## Technical Service Bulletin

GROUP <b>CAMPAIGN</b>	NUMBER <b>16-01-028-2</b>
DATE <b>JULY 2016</b>	MODEL(S) <b>2016 TUCSON (TL)</b>

HOOD SAFETY HOOK CATCH REPLACEMENT  
AND CLUSTER UPDATE (RECALL 145)

*This TSB supersedes TSB# 16-01-028-1 with updated cluster control logic software that helps minimize the ROM ID selection options based on cluster type during a MANUAL update. Certain steps of the service procedure have been revised.*

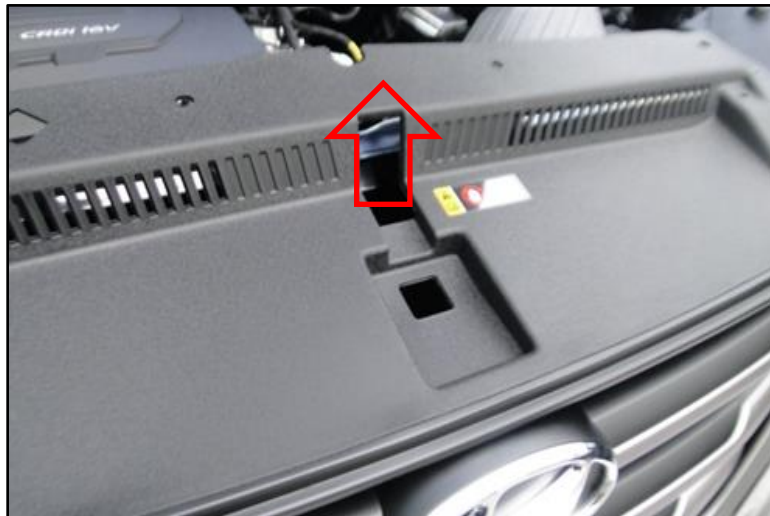
5. Open the hood. Remove the clips and bolts on the radiator grille upper cover.

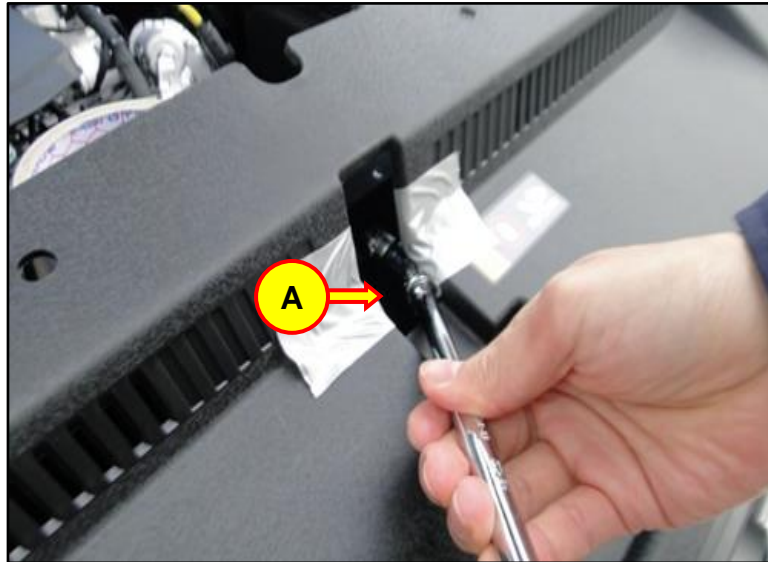
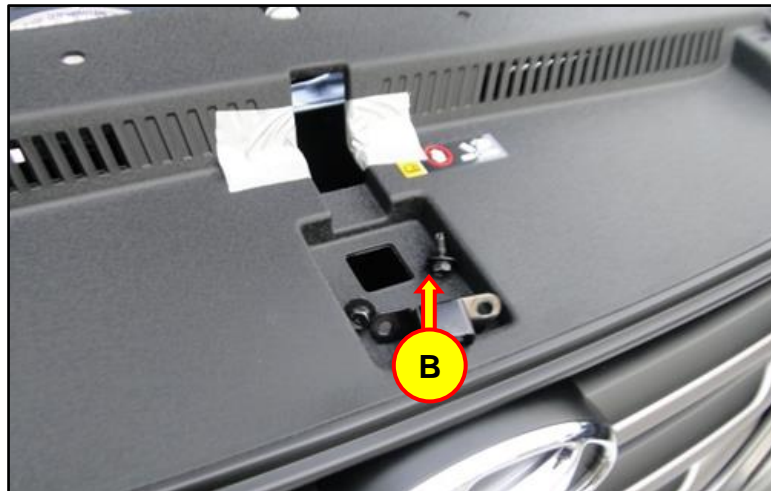
7. Apply the masking tape (A) around the radiator grille upper cover to prevent any scratches. Loosen the two hood catch mounting bolts inside the hole.

- a. ~ 11.8 Nm (0.8 ~ 1.2 kgf.m, 5.8 ~ 8.7 lb-ft)

8. Remove the hood safety hook catch (B) and install the replacement hood safety hook catch. Reinstall all the removed parts in reverse order of removal. Remove the masking tape.
